**MODIFICATION REQUEST:
CBD and South East Light Rail
Various Design Modifications (MOD 1)**

Secretary's
Environmental Assessment Report
Section 115ZI(2) of the
Environmental Planning and Assessment Act 1979

February 2015

Figure 9: Location of approved substation and proposed modified location of Surry Hills substation

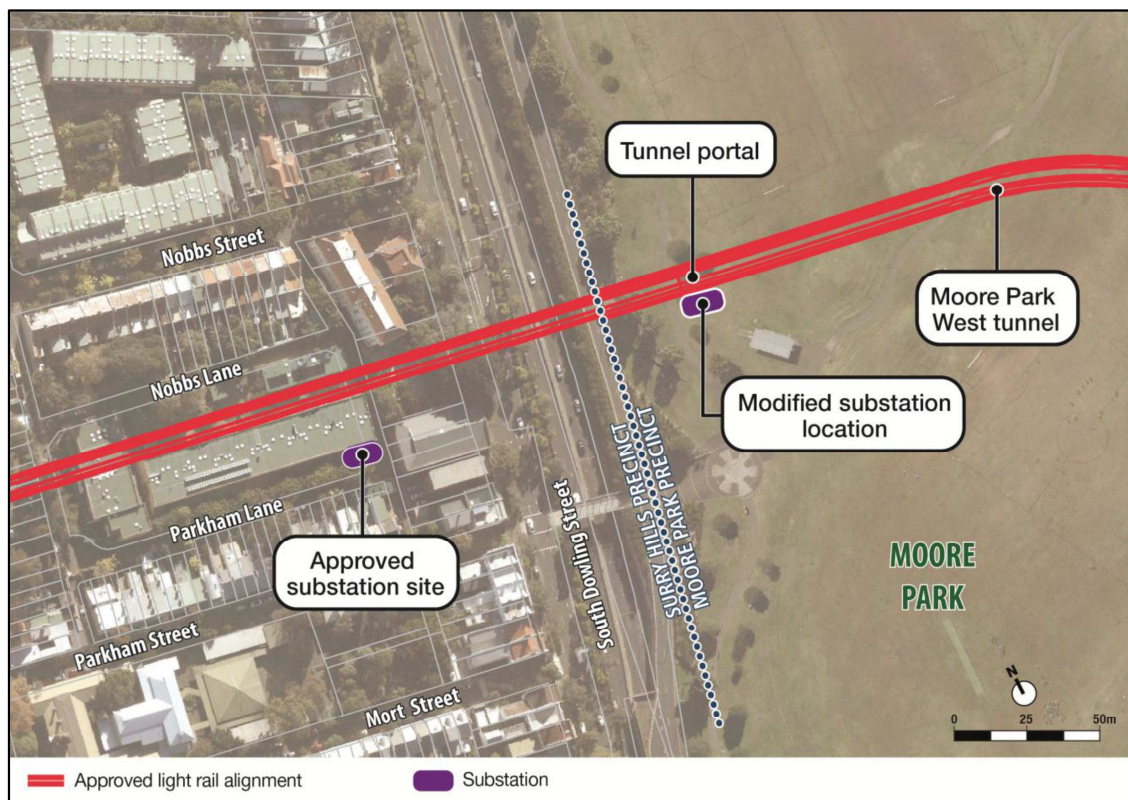
The Department considers that the relocation of the Surry Hills substation and removal of the High Street substation comprises a minor impact to the approved project. It is noted that the revised location of the Surry Hills substation would provide no further operational visual and landscape impacts or result in the loss of any additional trees. The Department also considers that the removal of the High Street substation would eliminate any visual impacts resulting from the approved project as originally proposed.

The submission received from the Centennial Park and Moore Park Trust noted a request that the substation be placed entirely underground with access and ventilation being provided from within the tunnel portal, so as to not be visible from the park. In response to this, the Department recommends modifying condition B39 to require that access to the substation be provided from within the Moore Park Tunnel portal, and that ventilation facilities be integrated with those of the tunnel itself. This would result in no additional visual and amenity impacts on Moore Park West. The Department is satisfied that the relocation of the

Surry Hills substation and the removal of the High Street substation would result in similar or improved noise and visual outcomes, and therefore recommends that it be modified.
